RE: Administrative Plan No. 62020008A
Edgemoor Lots 20, 21 & P/O Lot 2

**Department of Permitting Services
Fire Department Access and Water Supply Comments**

EDGEMOOR - LOTS 20, 21 & P/O LOT 2, BLOCK 8 ADMINISTRATIVE SUBDIVISION PLAN M-NCPPC #62020008A

FIRE HEIGHT RESTRICTED - SINGLE FAMILY DETACHED HOME DETAIL

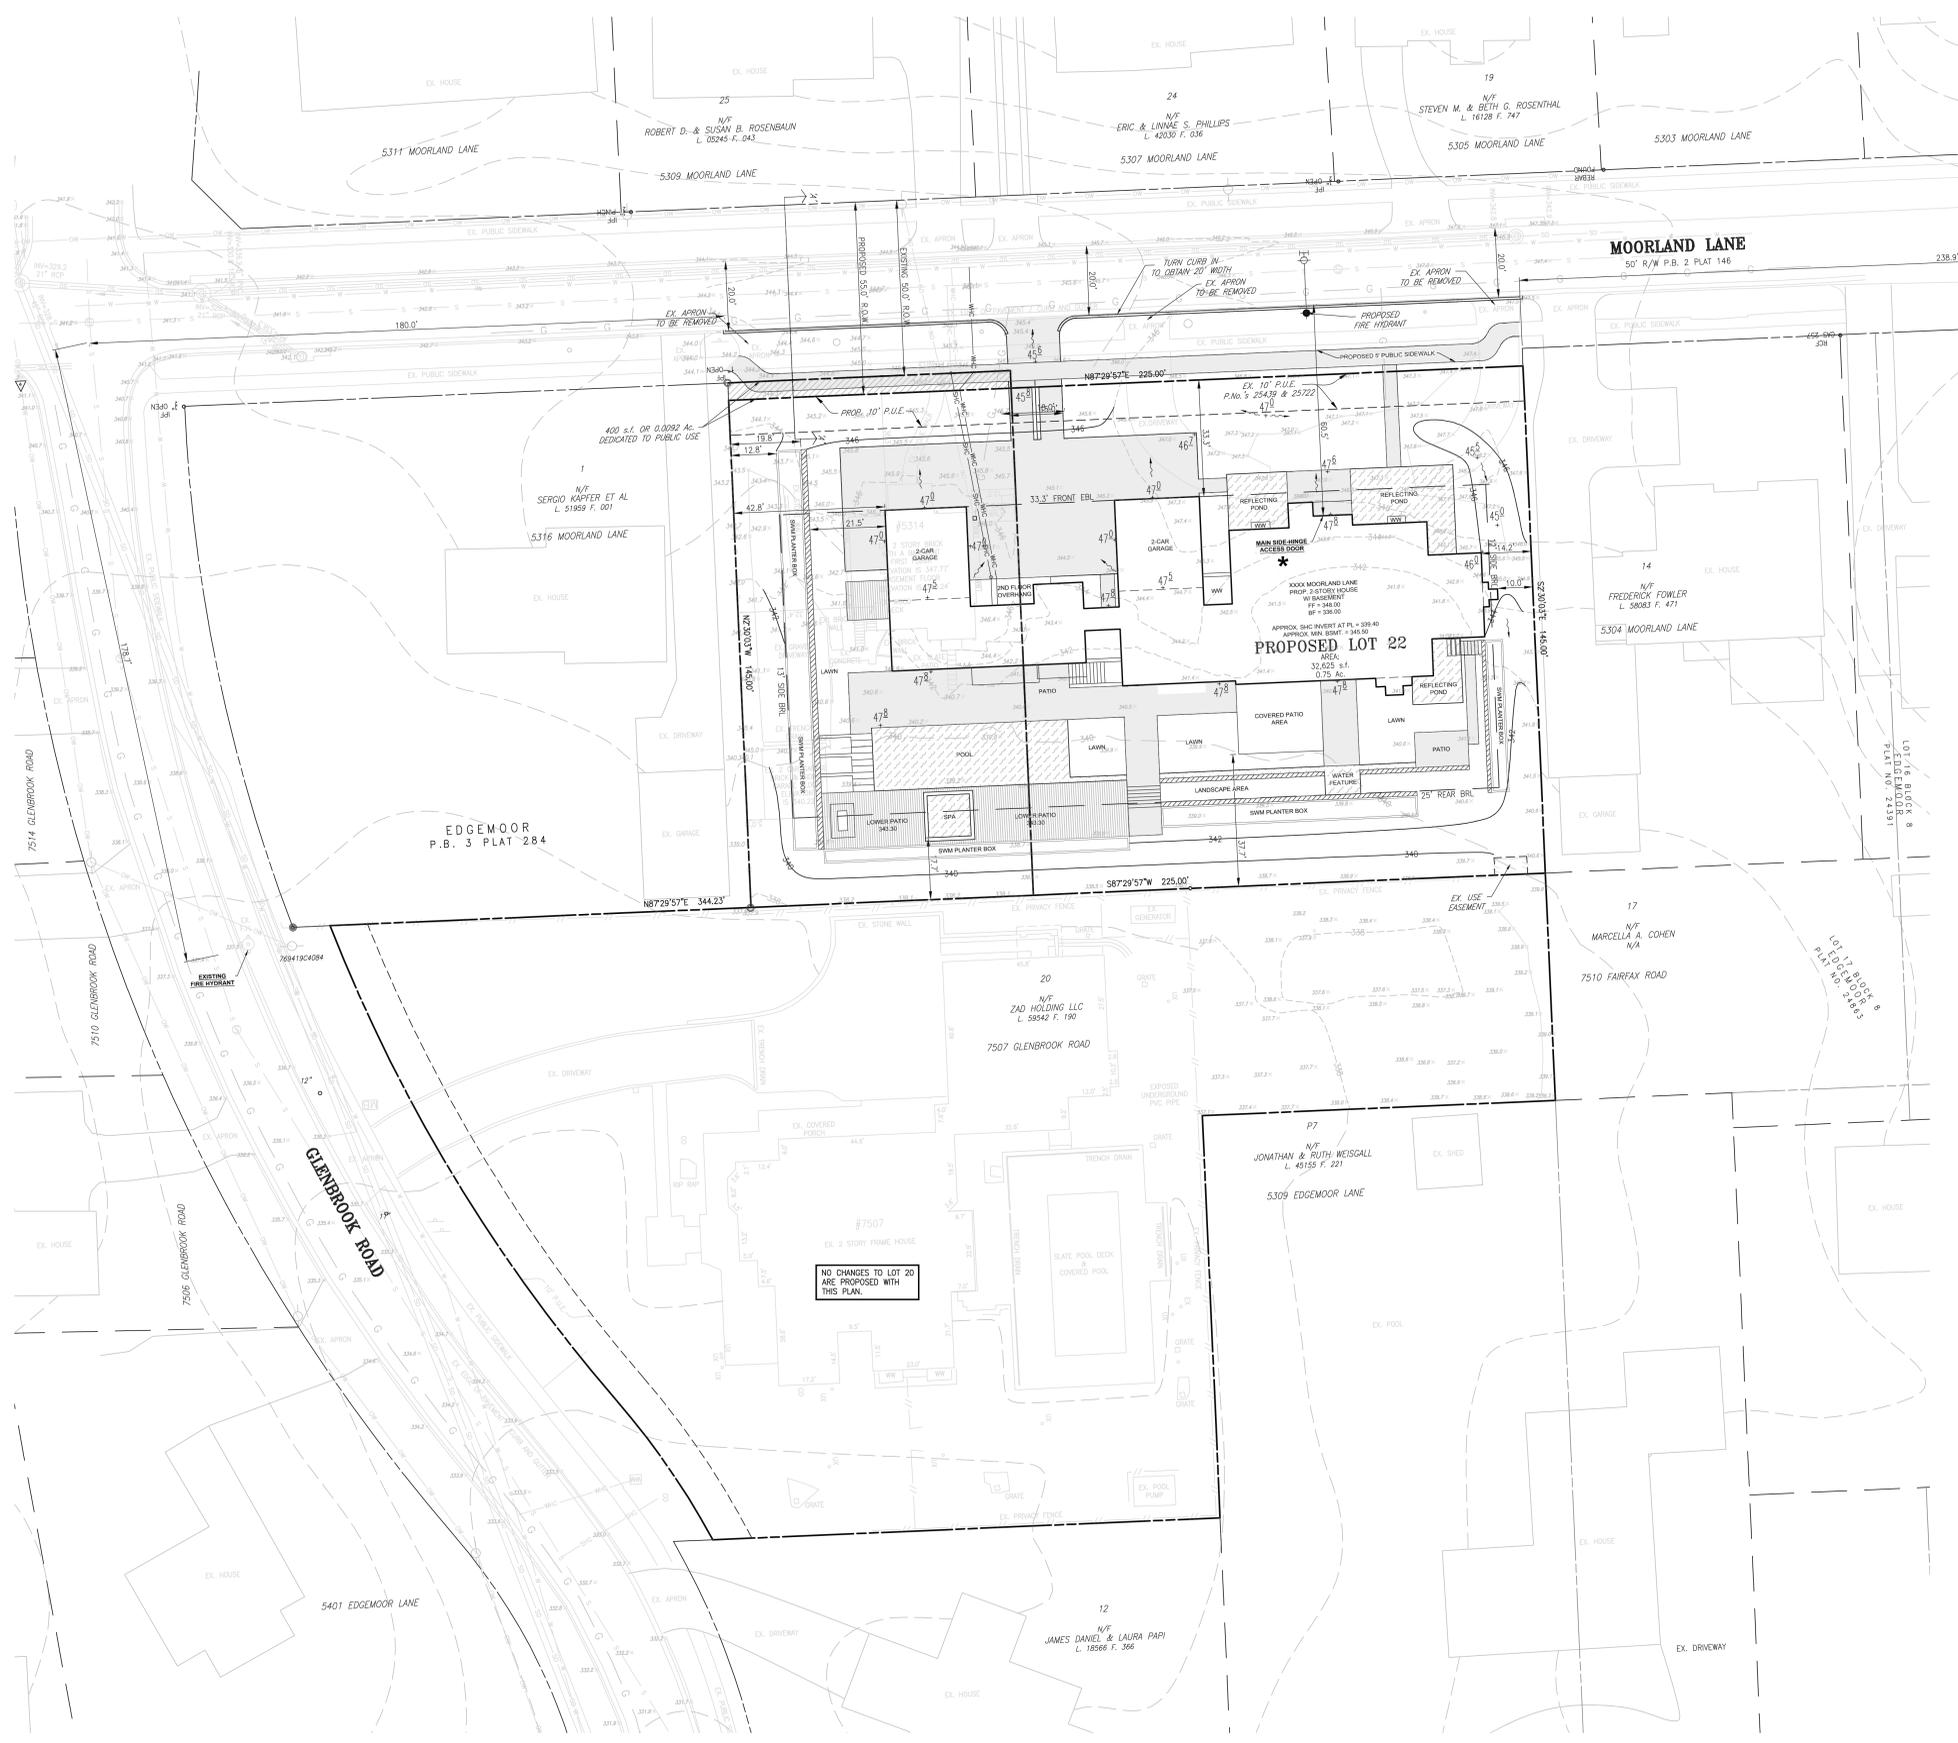
***** Detached single family unit is height restricted *****
